Drawing Change Notice

CHANGE DOCUMENT NO.
24590-LAW-P1N-P01T-00053

JOB NO. 24590
TITLE FOR CHANGE NOTICE
ADDITION OF ASX PLATFORM LP0301

TITLE OF DESIGN DOCUMENT
LAW VITRIFICATION BUILDING
GENERAL ARRANGEMENT
PLAN AT EL. 48'-0"

24590-LAW-P1-P01T-00005 REV 3

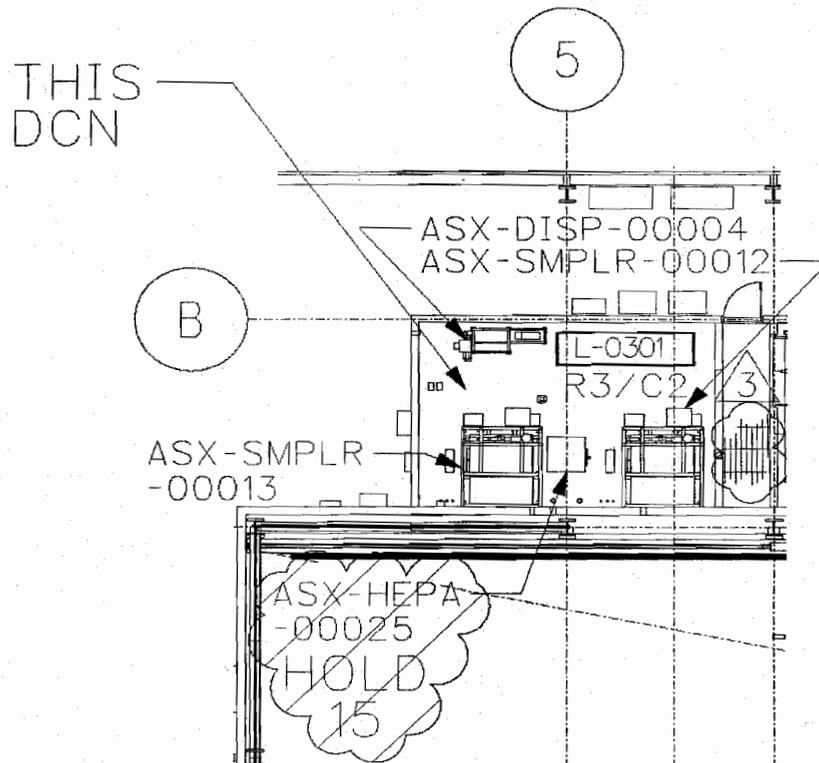
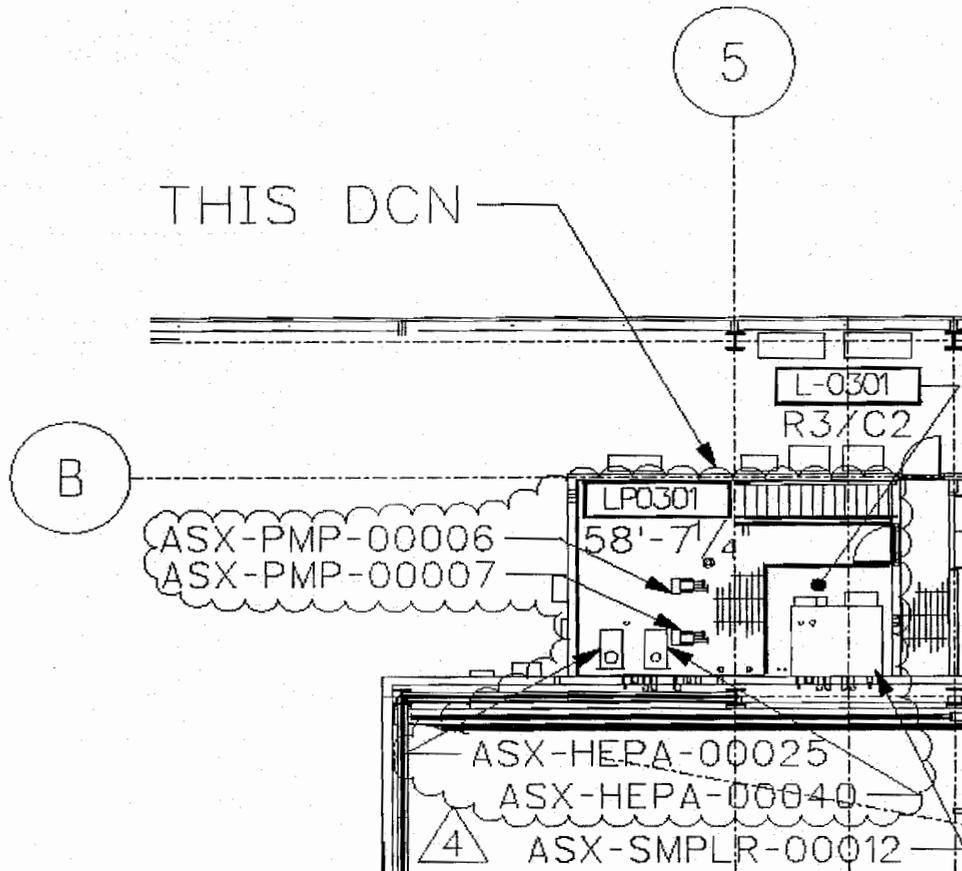
ADD PLATFORM LP0301, DOOR, ASX-HEPA-00040 AND ASX-PMP-00006/7. REMOVE HOLD 15.

THE FOLLOWING EQUIPMENT ASX-SMPLR-00012, ASX-SMPLR-00013 AND ASX-DISP-00004 WILL BE LOCATED BELOW PLATFORM LP0301 IN ROOM L-0301 AND WILL BE SHOWN ON PARTIAL PLAN. ASX-SMPLR-00012 AND ASX-SMPLR-00013 HAVE BEEN REVISED TO MATCH CURRENT VENDOR DATA.
